Service Bulletin

Bulletin No.: 03-07-30-017

Subject: Grind Noise or No Vehicle Movement when Shifting into Drive or Reverse
(Inspect Transaxle, Replace Various Transaxle Components)

Models: 1999-2002 Buick Century, LeSabre, Park Avenue
2002 Buick Rendezvous
1999-2002 Chevrolet Monte Carlo, Venture
2000-2002 Chevrolet Impala
1999-2002 Oldsmobile Intrigue, Silhouette
1999-2002 Pontiac Bonneville, Grand Prix, Montana
2001-2002 Pontiac Aztek
with Transaxle Auto 4-SPD, 4T65-E (RPO MN3)

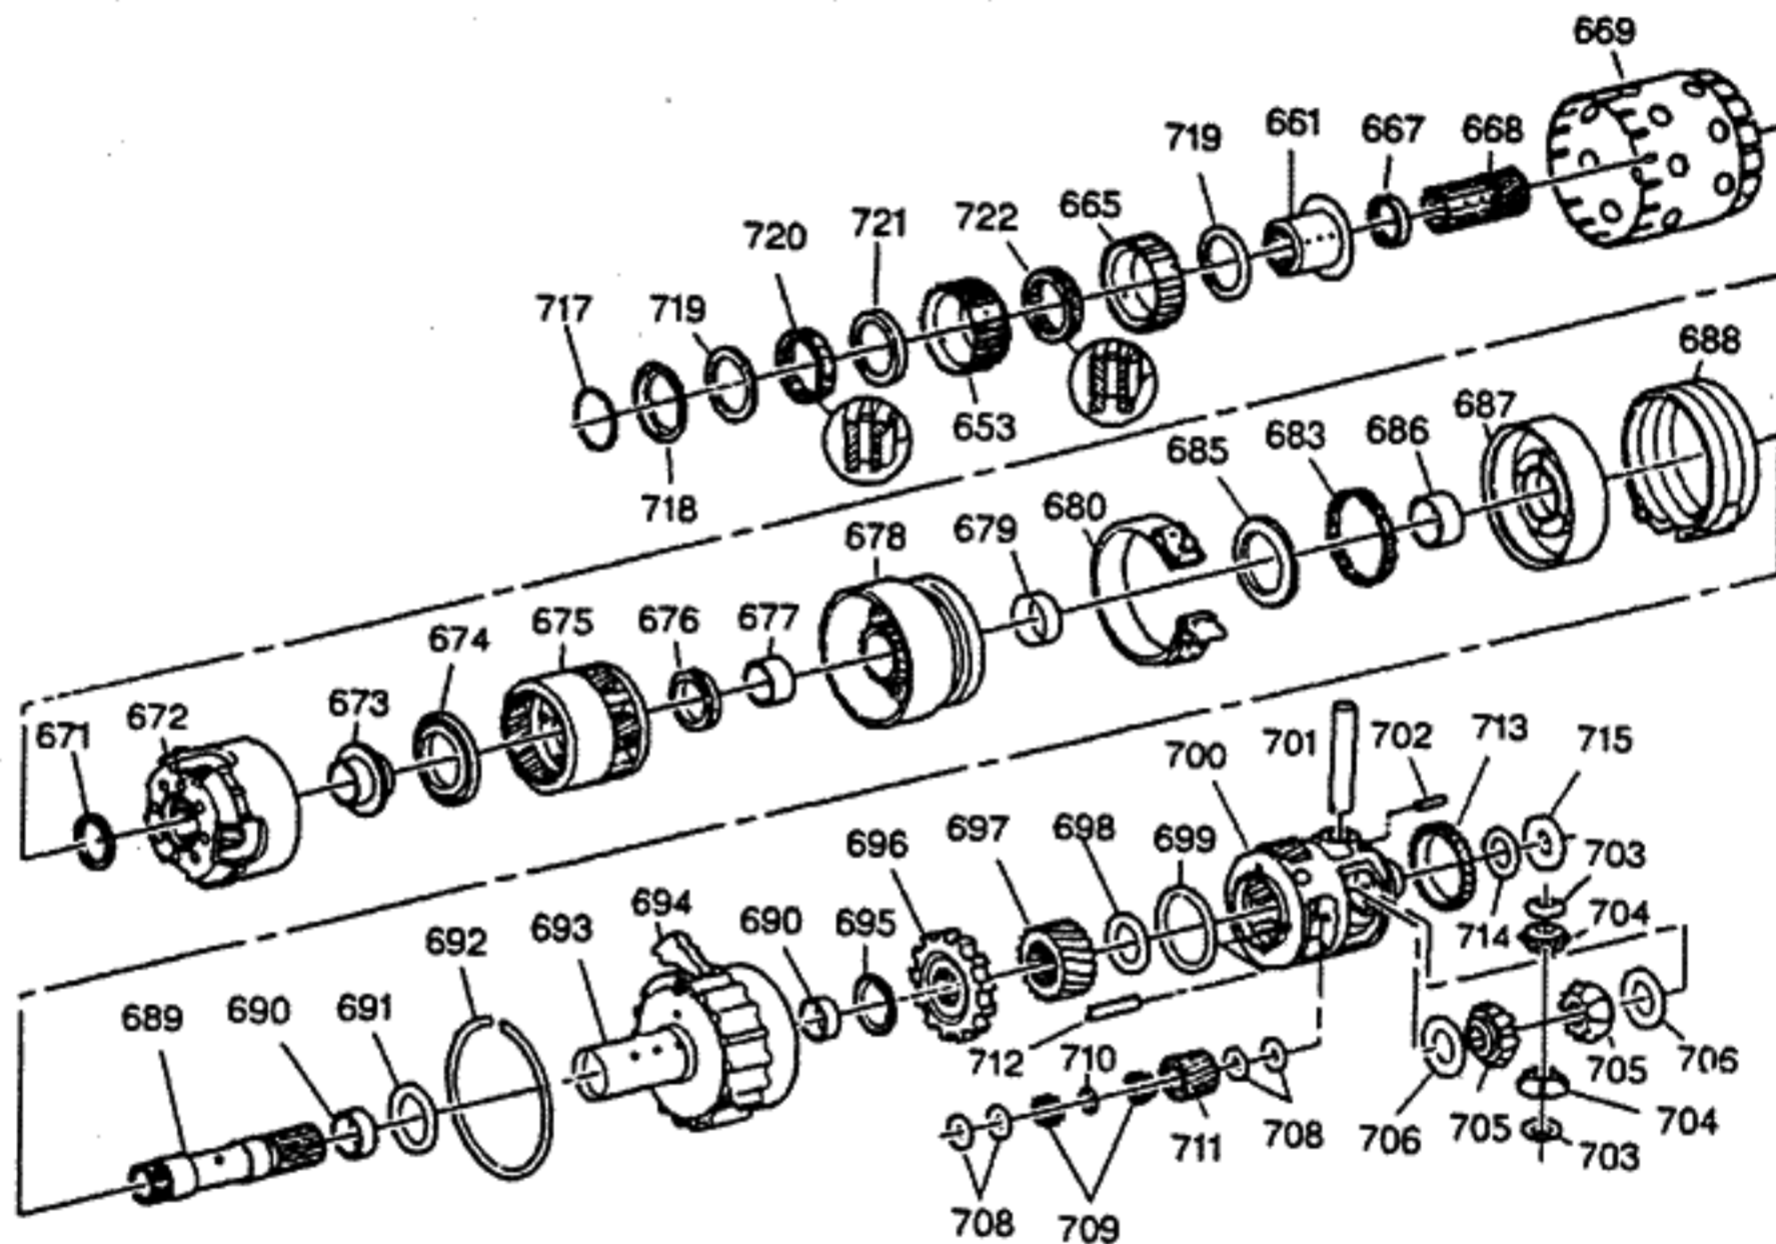
Important: If metallic debris is found on the transaxle pan magnet, the transaxle must be completely disassembled and cleaned. Failure to properly clean the transaxle case and internal components may lead to additional unnecessary repeat repairs.

1. Remove the transaxle oil pan and inspect the magnet in the bottom of the pan for metal debris. Refer to SI Document ID #414136.
2. Remove the transaxle from the vehicle. Refer to the appropriate SI document.
